PLANNING COMMITTEE REPORT
18 AUGUST 2020

<p>APPLICATION FOR CONSIDERATION:</p>	<p>DAWLISH - 20/00933/NPA - Coastguards Breakwater To Colonnades Breakwater And Dawlish Railway Station, Station Road - Application for prior approval of siting and appearance under Part 18 Class A of the Town and Country Planning (General Permitted Development Order) 2015 of proposed Coastal Resilience Works to Railway Infrastructure to include a new taller sea wall between two existing breakwaters incorporating a wider higher public promenade with a link structure to join Marine Parade and new ramped pedestrian access to beach adjacent to and adjoining the railway station. Other works to include the demolition of the coastguards building, works to the station including reconstructed downside station platform, new accessible passenger footbridge and refurbishment of passenger waiting room</p>	
<p>APPLICANT:</p>	<p>Network Rail</p>	
<p>CASE OFFICER</p>	<p>Helen Addison</p>

20/00933/NPA - Coastguards Breakwater To Colonnades Breakwater
 And Dawlish Railway Station
 Station Road, Dawlish
 EX7 9PJ

The Accessible Station Footbridge

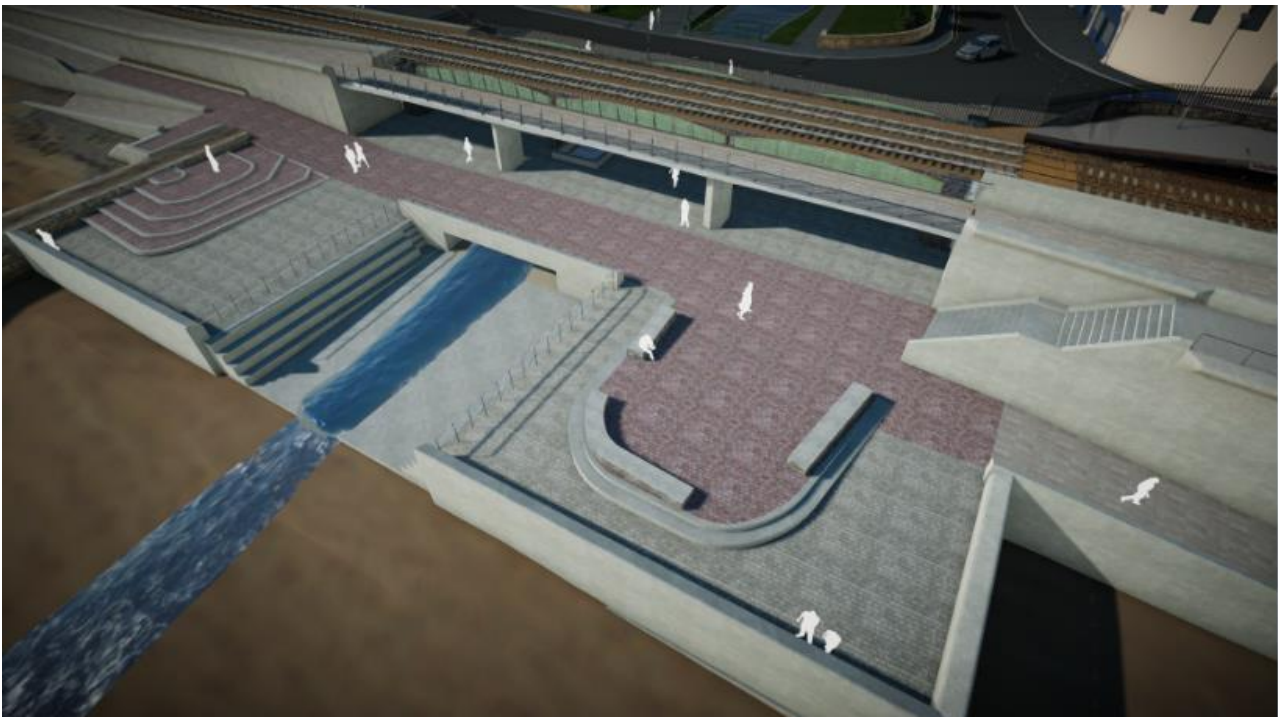
- 1.95. Construction of the new accessible footbridge would constitute a modern intervention to the station. It would be sited to the north of the existing building so that there would be a clear separation between the two structures. The scale of the bridge is notably larger than the station building, particularly in terms of height. HE comment that “the two uprights squared lift towers form a significant and dominant structures within views of the station. This is further exacerbated by the choice of Patterned Glass Reinforced Concrete (GRC), the hard finish of which will add to the visual dominance of the proposed footbridge:.... We would advise that further consideration is given to the design of the structure. This should aim to address the shape and hard finish of the proposed towers, whose upper sections would benefit from greater refinement in their design. This could be through the choice of materials, colour and the creation of a greater texture or motif to break up the stark quality of the current design”. The Council’s Conservation Officer has also commented on this part of the application saying “it is a great pity that the attractive polygonal shape of the footbridge platform is not complemented by a slight batter to the outer sides of the lift towers, in an echo of the angled glacis of the station understorey, and sea wall”.

- 1.96. NR have been asked to review the external finish of the proposed footbridge and to provide further illustrative material showing what it will look like.

The main intervention is the proposed new contemporary footbridge intended to provide access for all. Located north of the station complex, consideration has been given to separating it from the main station complex and limiting its impact on views from the town, However, the two uprights squared lift towers form a significant and dominant structures within views of the station. This is further exacerbated by the choice of Patterned Glass Reinforced Concrete (GRC), the hard finish of which will add to the visual dominance of the proposed footbridge.

The Boat House and Coastguards steps

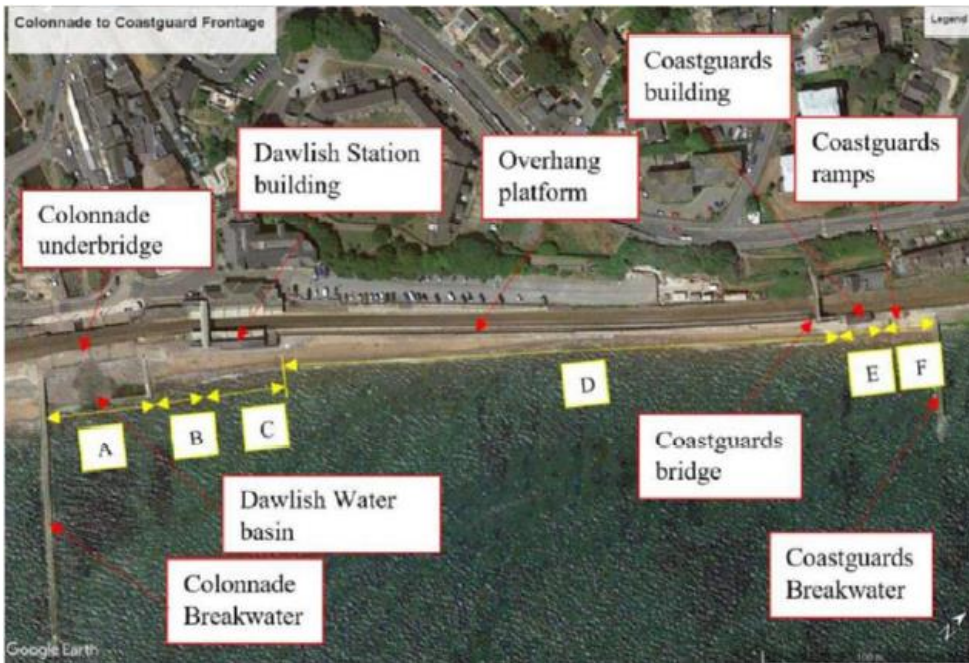
- 1.64. Demolition of the Coastguards Boat Shed with the exception of the rear wall which would remain in situ and the lower portion of the Coastguard's Footbridge steps would change the appearance of the area immediately surrounding it. The loss of the Boat Shed would mean that part of the distinctive character of this section of the promenade would be lost, which would detract from the legibility of the area. The upper part of the footbridge steps would be retained and the lower parts would be obscured including the granite façade.

The boathouse and the footbridge are identified as non-designated heritage assets and are located within the conservation area. The proposals comprise the demolition of the boathouse and would obscure the lower section of the bridge. As they are not listed we do not propose to comment in detail although we note that these early structures are connected to the railway and Coastguards, and are interesting structures in their own right, both contributing to the significance of the listed station (as derived from its setting) and the conservation area.
